JKL COMPONENTS Change Notice

CUSTOMER	CUSTOMER DRAWING or PART NUMBER		REV. NO.	TODAYS DATE
				5/11/2021
JKL PART NUMBER(s)	PART DESCRIPTION		Part Family	
ENW1-EW87	T-1 1/2 Neo Wedge PCB lamp, 14V		T-1 1/2 Neo Wedge	
JKL CONTACT NAME	PHONE	EMAIL:

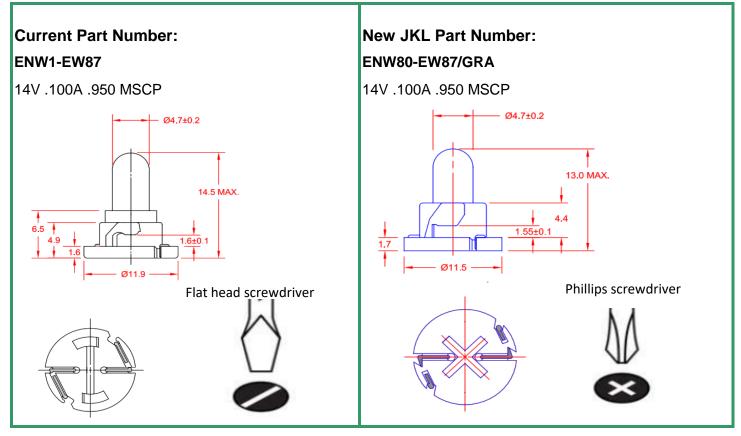
This item has been replaced by a new design that is a drop in replacement (form-fit-function).

The old base bottom is designed to be installed with a flathead screwdriver.

The new base bottom is designed to be installed with a Phillips screwdriver.
